2ND AND VIRGINIA

1931 2ND AVENUE EARLY DESIGN GUIDANCE #2 | JULY 23, 2019 | DPD #3033067-EG

KENGO KUMA // ANKROM MOISAN ARCHITECTS // BERGER PARTNERSHIP // PACIFIC VIRGINIA

Departure 1

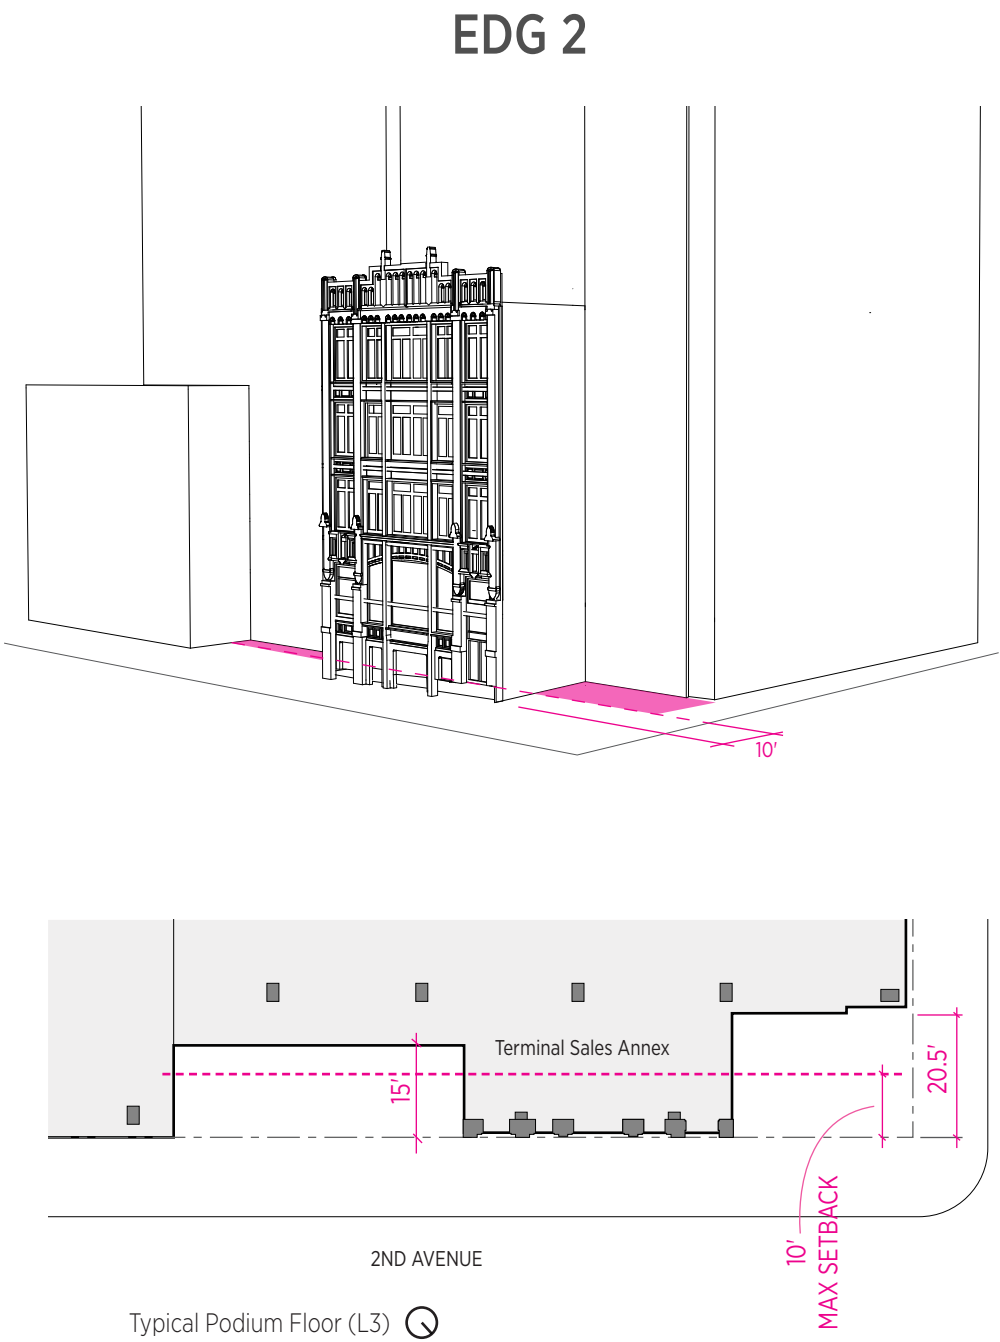
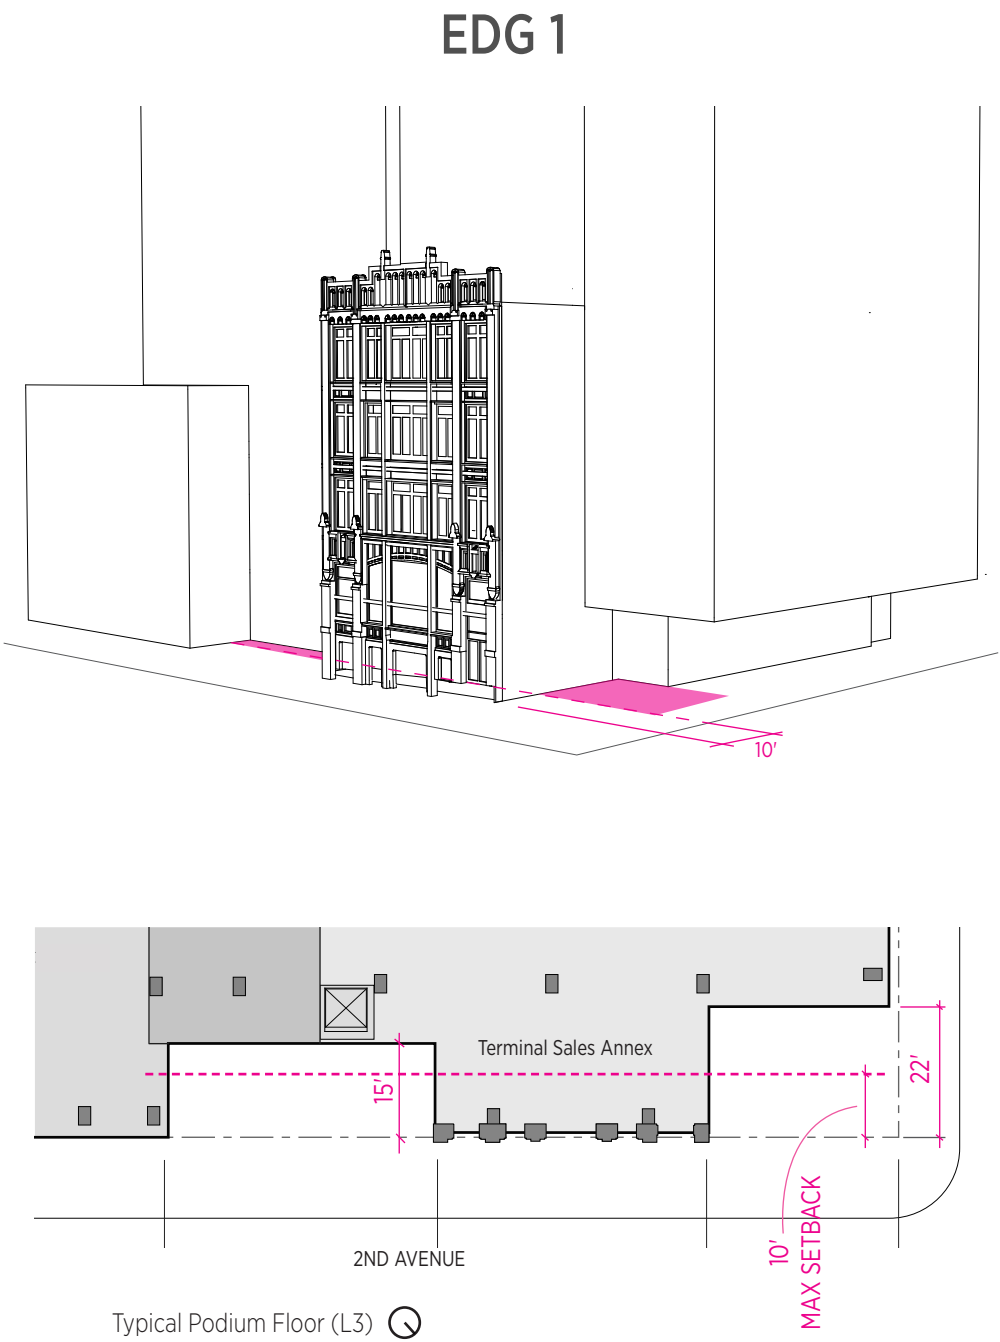
REQUEST:
A departure is requested to setback the facades surrounding the Terminal Sales Annex (TSA) greater than 10'. We are requesting 15' on the south and 20.5' on the north.

JUSTIFICATION:
South of the TSA: The #1 priority of the Landmarks Preservation Board (LPB) is to set back the new tower from the landmark structure. In conversations with the ARC over the years, a 15' setback is a reasonable starting point for tower setback from the Landmark. In this location, which supports our overall design concept, the tower form comes down the ground thus creating the 15' setback.
North of the TSA: As the tower begins to telescope and step back from the Landmark, the setback dimensions transition from 15' to 22' at the corner. This tower setback allows visibility to the Terminal Sales Annex and creates a grand open space to denote entry and respite for pedestrians.

Departure 2

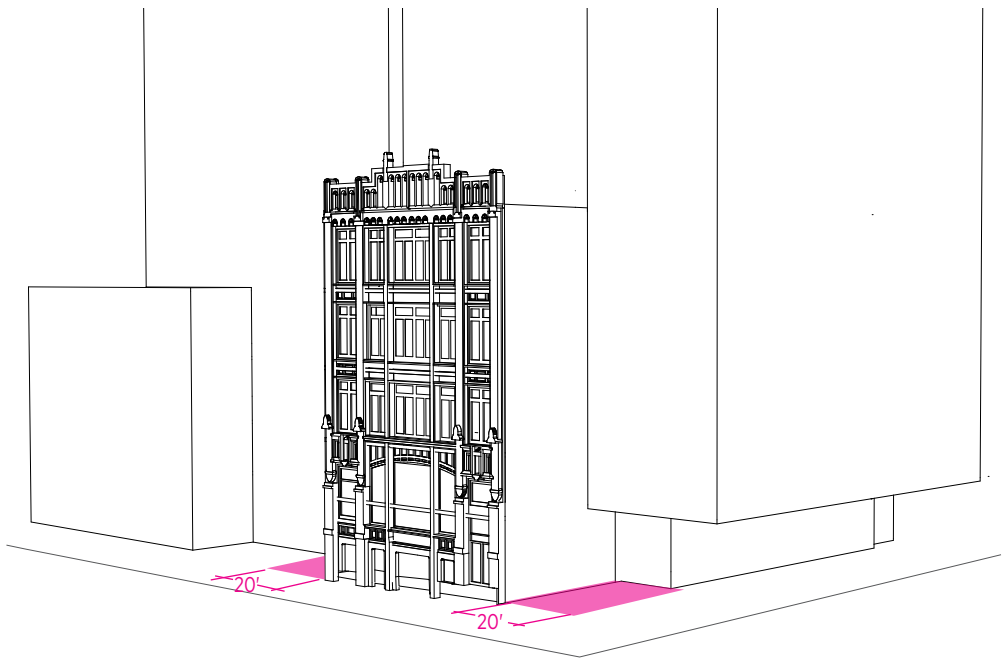
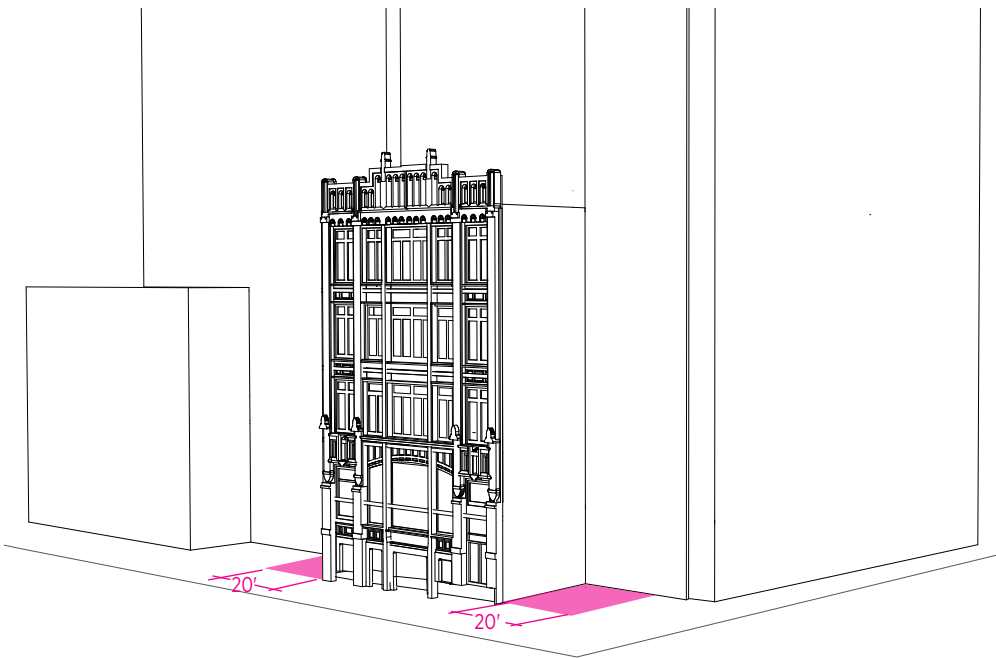
A departure is requested to increase width of setback to relate to the TSA on the south, while opening the corner to Landmark on the North. We are requesting 43' on the south and 30' on the north.

South of the TSA: The width of the setback on the south of TSA is directly related to the width of the TSA itself. The TSA is approximately 45' wide and the width of the setback is approximately 48'. This width also is directly related to the proportions of the tower's telescoping form concept.

North of the TSA: To create a corner open space and for the Landmark to 'front' the corner, a greater setback is required. This corner open area reveals the lower edge of the tower as it descends from above, hovering just above ground at the main entry.

Departure 3

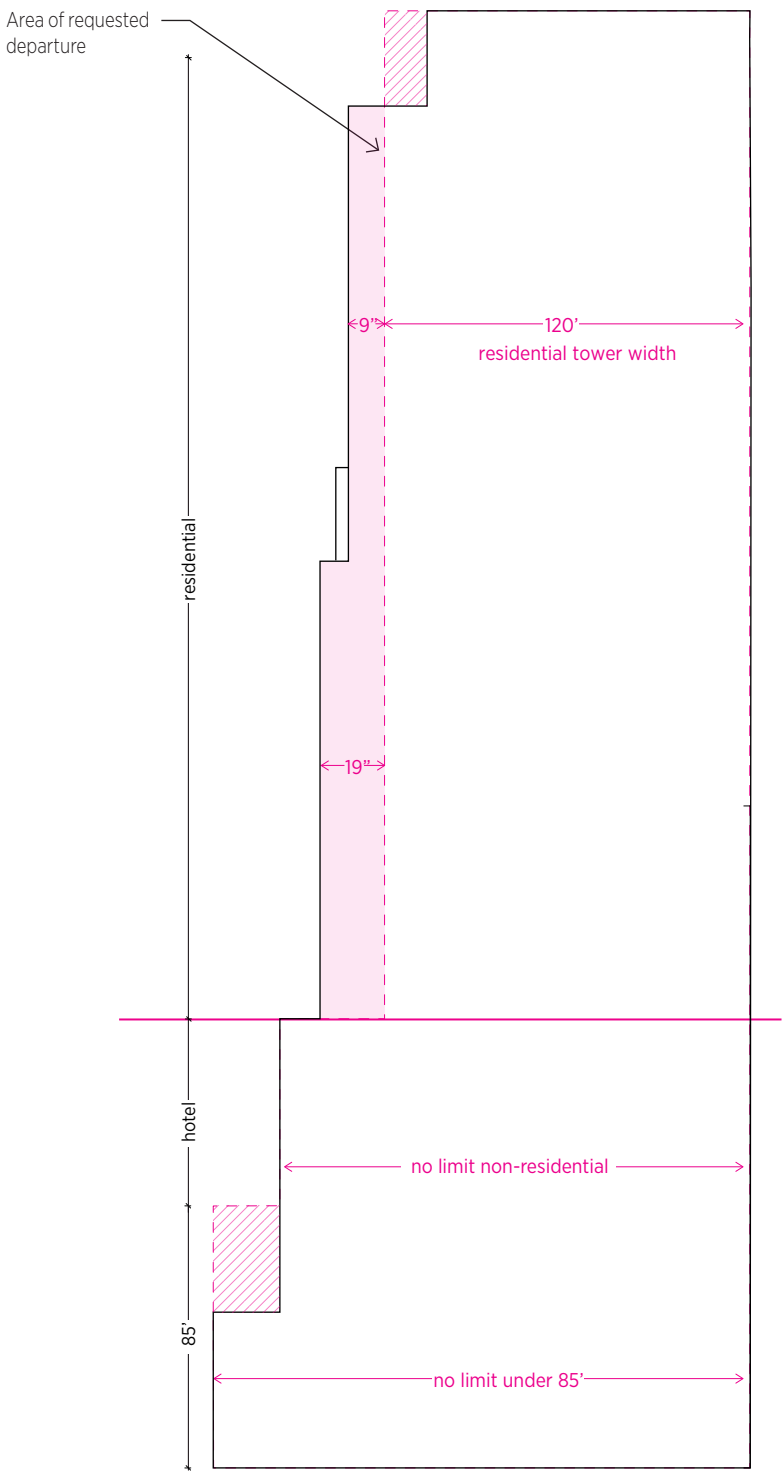
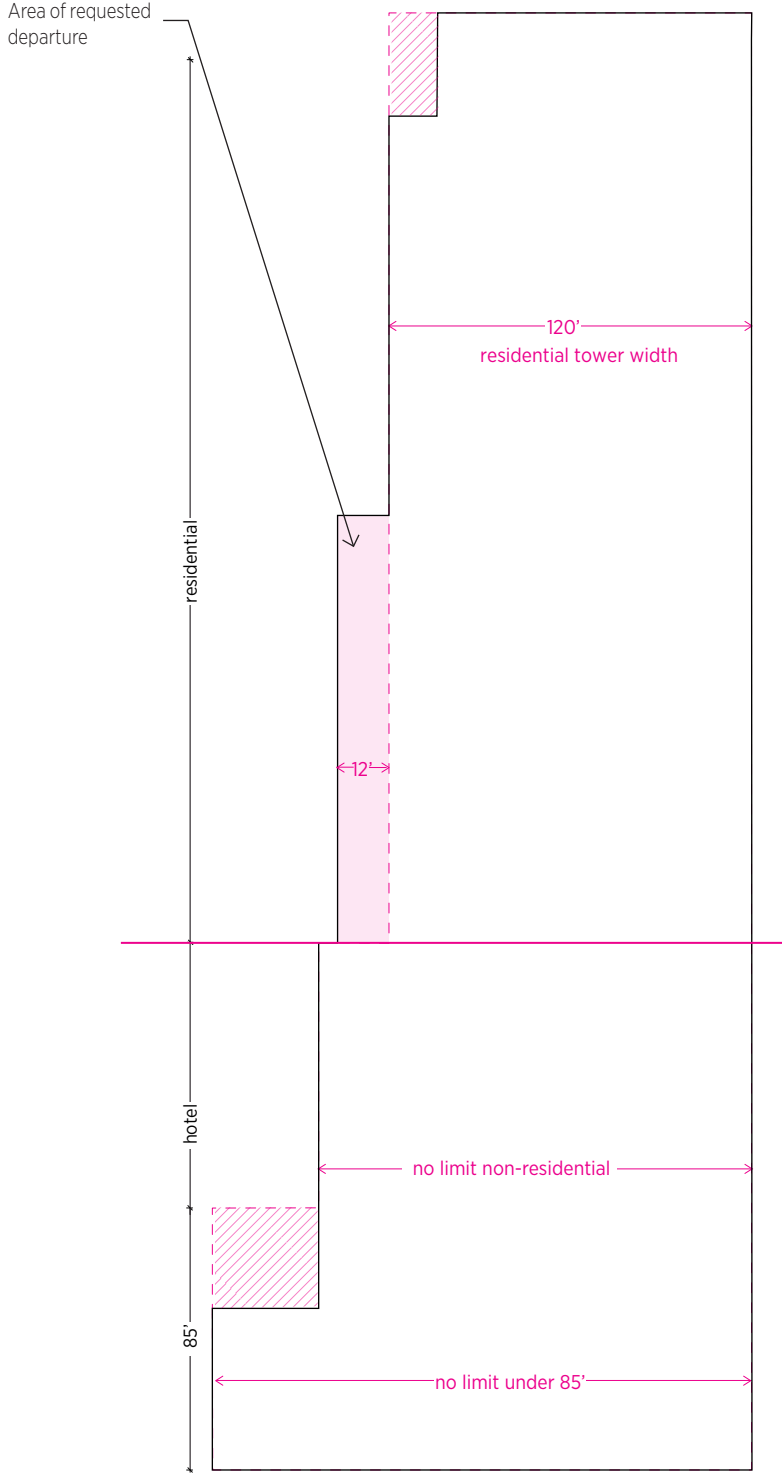
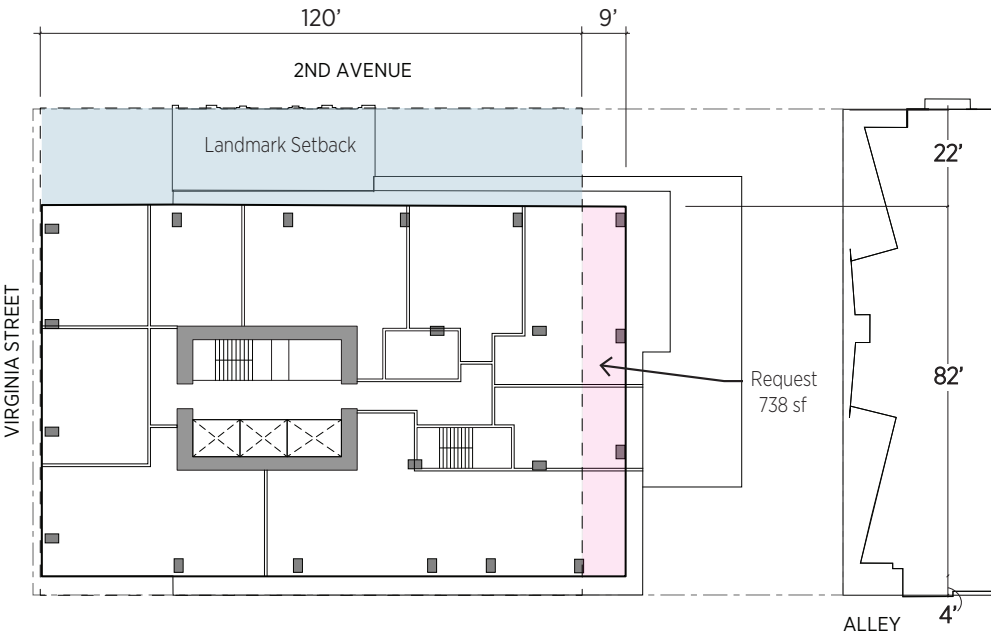
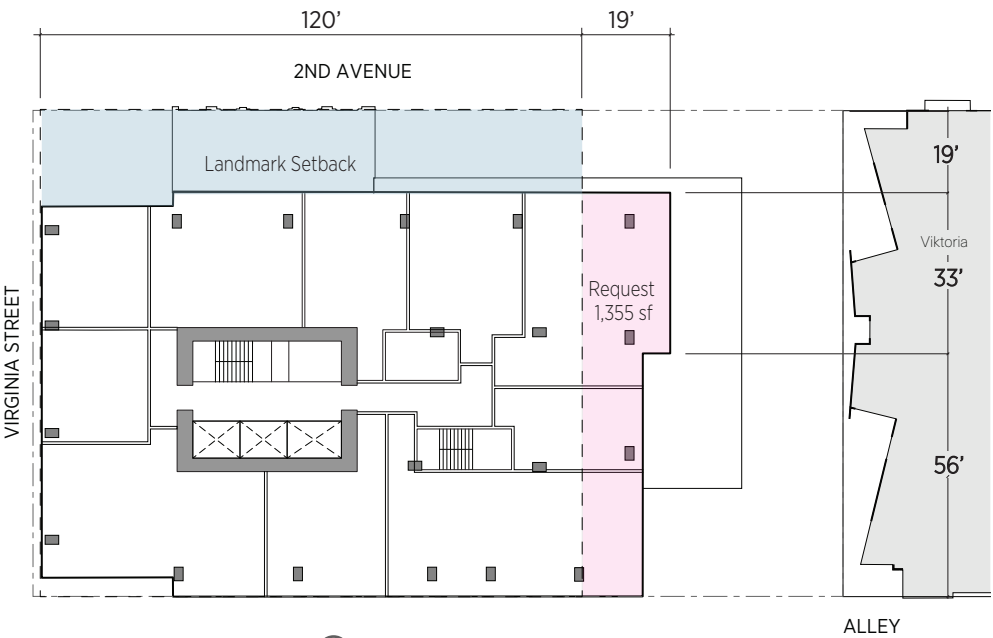
REQUEST:
A departure is requested to extend the residential portion of the tower by 12’ at the widest section.

JUSTIFICATION:
The current maximum facade width is not ideal for the historic landmark on site. When the tower sets back from the landmark, it immediately creates a more rectangular tower which does not allow an average tower plate of 10,700sf without increasing the overall width. By setting the entire tower back from the landmark by 18’, it essentially widens the tower to create an average residential footprint of 10,500sf.
At EDG 1, the project team had requested 19’ of additional width at Levels 14-27, and additional 9’ at Levels 28-41. At EDG 2, the project team has significantly reduced the tower width to better meet the tower width requirement. The project now meets the tower width requirement at the top portion of the tower, and a departure is only requested at the middle section of the tower. The Architectural Review Committee is supportive of this departure.

- The overall tower width has been reduced to 120'-0" at Level 30
- The total average floor plate is 10,500 sf, 200 sf under the maximum floor plate allowed.
